APPLICATION NO.	FILING DATE	FIRST NAMED INVENTOR	ATTORNEY DOCKET NO.	CONFIRMATION NO.
10/069,001	02/20/2002	Yuji Sawada	0992-0127P	4536
2292	7590	12/21/2005	EXAMINER	
BIRCH STEWART KOLASCH & BIRCH PO BOX 747 FALLS CHURCH, VA 22040-0747			ALEJANDRO, RAYMOND	
			ART UNIT	PAPER NUMBER
			1745

Office Action Summary

DETAILED ACTION

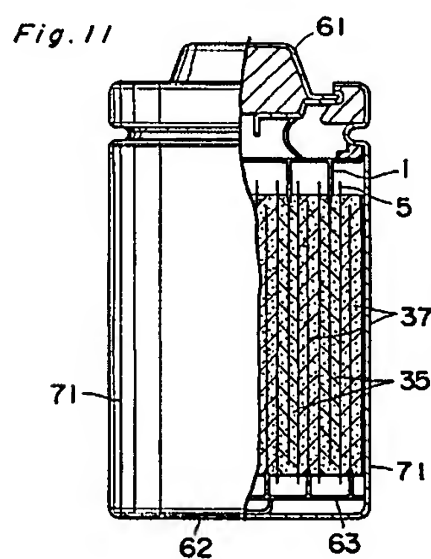
Nonoka et al disclose a lithium ion secondary battery as shown in Figure 11 comprising a positive electrode 35, a negative electrode 37 and a film separator 5 for separating both electrodes 35 and 37 (SECTION 0015). It is further disclosed that a porous polypropylene film is used as the separator (SECTION 0035); and in conventional lithium secondary batteries, aluminum foil is formed with natural oxide films on its surface so that thin isolating film have often been formed in the interface therebetween (*the inert protective or passive film formed by oxidative of said metal*) (SECTION 0015).

Figure 11 below illustrates the battery comprising at least a negative electrode 37 and a film separator 5 and forming a laminate structure (*←emphasis added*). Thus, Nonoka et al directly embodies a laminate layered-structure including a polyolefin film (the separator film) in contact with an aluminum foil which has thereon a natural oxide film. Accordingly, Nonoka et al also provide the necessary structural interrelationship to meet the claimed requirement of a metal layer having a surface-treated layer formed thereon which is an inert protective layer or passive film; and a layer of a polyolefin formed over the surface treated layer.

Nonoka et al disclose a battery laminate structure as seen and described. However, the preceding prior art does not expressly disclose the specific order of layers.

To that end, it has been held that re-arrangement, reversal or duplication of parts is obvious. Succinctly stated, fact that a layer of the claimed laminate is structurally re-arranged, reversed or duplicated is not sufficient by itself to patentably distinguish over an otherwise old feature unless there are new or unexpected results as it is a matter of choice which a person of ordinary skill in the art would have found obvious absent persuasive evidence that the particular configuration of the claimed order of layering (specific laminate structure) was significant. In re Japikse 86 USPQ 70. In re Kuhle 188 USPQ 7. In re Gazda 104 USPQ 400. In re Harza 124

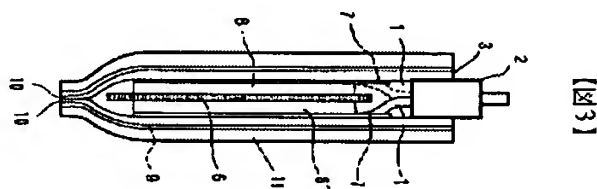
It is disclosed that the sealing bag is formed with a material stuck together with plastic layers inserted with a metal layer such as aluminum foil and a metal deposition layer, a PET film is stuck thereto and a thermoplastic resin such as polyethylenene is also stuck thereto (Abstract/Solution). **Figure 3** below illustrates the specific layered structure of the sealing feature, particularly, the Al foil 9, the plastic layers 11 and the heat seal layers 10.

With respect to the surface treated layer: the JP'808 document also discloses that the sealing bag 3 preferably comprises a laminated material comprising a substrate having a metallic vapor deposition layer sandwiched between plastic layers 10 and 11 (SECTIONS 0010-0015). *Thus, the substrate itself having the metallic vapor deposition layer acts as the surface-treated layer over the substrate surface.* Furthermore, it is also disclosed that the plastic film 11 and the

metallic foil layer 9 are adhered to each other by using adhesive, such as urethane, epoxy and polyester resins (SECTIONS 0010-0015). *Hence, the foregoing adhesive layer, to some extent, chemically treat the surface of the Al foil or the metallic layer.*
